Mobile Intel[®] Pentium[®] II Processor Specification Update

Release Date: March 2006

Order Number: 243887-051

The Mobile Pentium[®] II processor may contain design defects or errors known as errata which may cause the product to deviate from published specifications. Current characterized errata are documented in this Specification Update.

Figure 1. TAP Gageable Thread Clarification

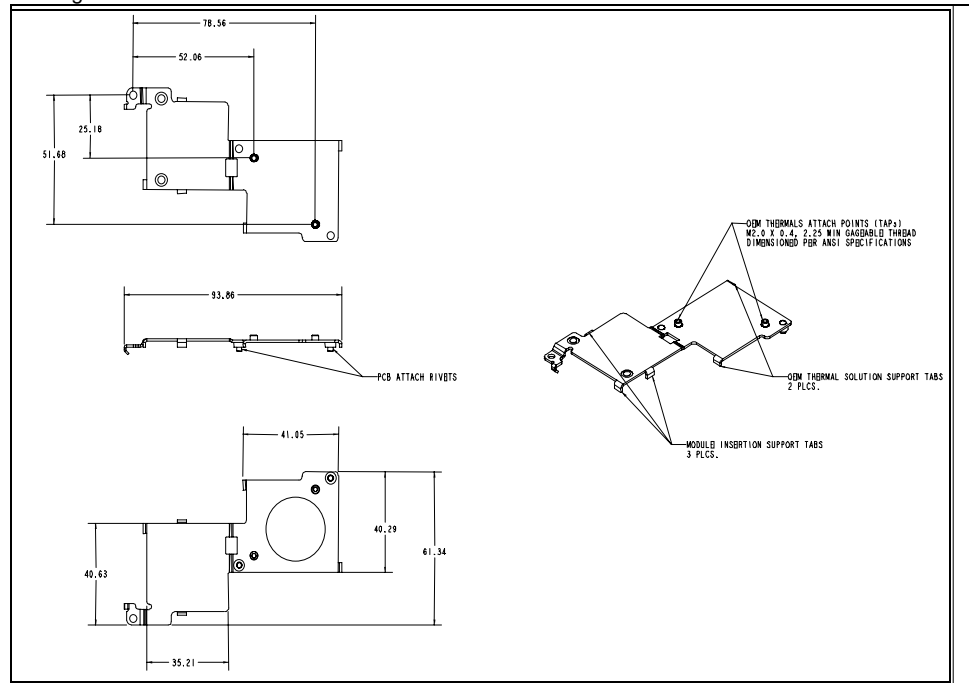
In the *Intel® Pentium® II Processor Mobile Module : Mobile Module Connector 1 (MMC-1)* and the *Intel® Pentium® II Processor Mobile Module : Mobile Module Connector 2 (MMC-2)* datasheets (Order Numbers 243667 and 243668, respectively), the thermal attach point (TAP) gageable thread specification was not clearly identified in Figure 14, of Section 5.2. The following is the TAP clarification:

OEM Thermal Attach Points (TAPs) M2.0 x 0.4, 2.25 min gageable thread dimensioned per ANSI specification.

See Figure 1 below for more information.
